MAXWELL UNDERGROUND MINE PROJECT

MINING OPTIMISATION MODIFICATION **SUBMISSIONS REPORT**

Figure 3

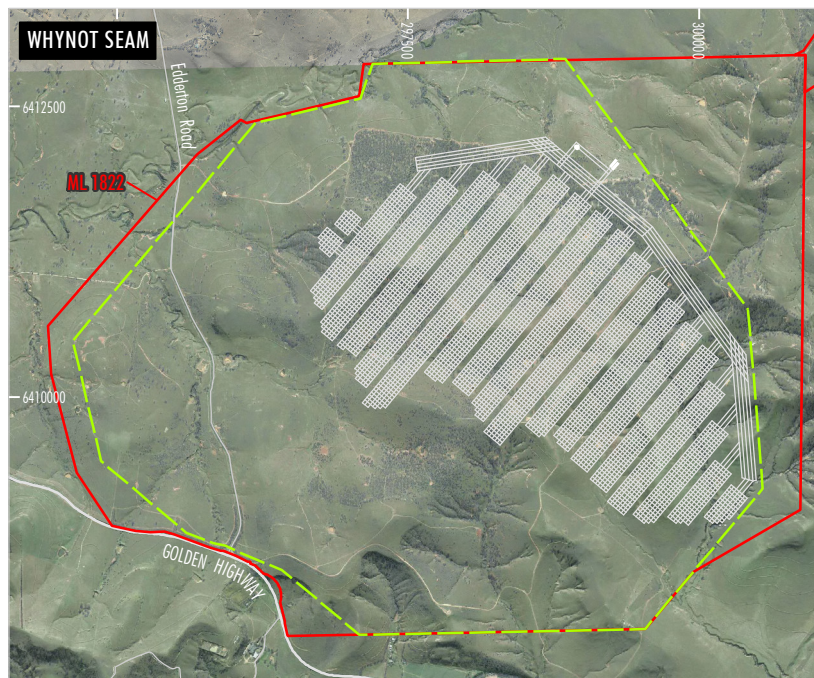
The HTBA and Coolmore and Godolphin Woodlands Studs objections refer to a report prepared by Mr Peter Scott (dated 24 November 2020) that was presented to the IPC as part of the assessment and determination process for the approved Project. Mr Scott's 2020 review of the EIS Subsidence Assessment misinterpreted the subsidence prediction methodology applied by Mine Subsidence Engineering Consultants (MSEC, 2019) and peer reviewed by Professor Bruce Hebblewhite (i.e. the Incremental Profile Method applied by MSEC does not rely on angle of draw to determine potential subsidence impacts).

In submissions on the Modification, the HTBA and Coolmore and Godolphin Woodlands Studs have referred again to Mr Scott's 2020 report to raise the following concerns regarding the Modification:

- the increased proximity of the angle of draw to the Hunter River and Saddlers Creek; and

- the Modification would result an exceedance of the subsidence performance measures set out in Condition C1 of Development Consent SSD 9526, particularly with respect to the Hunter River and Saddlers Creek.

MSEC (2022) state the following regarding potential impacts of the Project (as modified) on the Hunter River and Saddlers Creek (emphasis added):

- *The thalweg of the Hunter River is located at a minimum distance of 470 m from the modified mining area. At this distance, the predicted vertical subsidence at the river channel is expected to be negligible. The predicted conventional tilts, curvatures and strains are not expected to be measurable.*

- *The thalweg of Saddlers Creek is located 125 m from the modified mining area, at its closest point. At this distance, the predicted vertical subsidence at the creek channel is expected to be negligible. The predicted conventional tilts, curvatures and strains are not expected to be measurable.*

These findings are consistent with the key findings of the Subsidence Assessment prepared for the approved Project (MSEC, 2019). Accordingly, the Modification is not considered to present additional risk of material adverse subsidence impacts occurring to the Hunter River or Saddlers Creek.
